NV15, 4MX16 TERMINATED DDR, RGB, INTERNAL DVI-I, TV I/F, AGP4X.

GPU : GeForce2 PRO

MS-8836

History based on P30-B02
Saturday, August 11, 2001 Sheet 1

NV15 DDR POWER ADDER

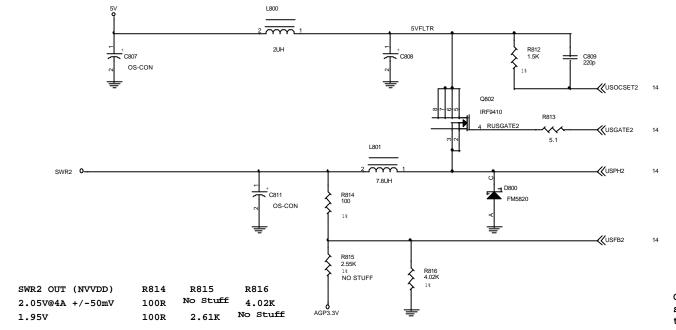
I=(3.3-0.5-2.05)/(10/10)=750mA typ

Our measurements show that we are consuming slightly more power on the AGP 3.3V supply than the AGP spec allows. The attached circuit is needed to supply some power to the NVVDD circuit from 3.3V and thus reduce the power need on 5V to be below AGP limit. Please implemement this circuit on 8836.

R816=100/((2.05V/2)-1) R815=130/(2-1.95v)
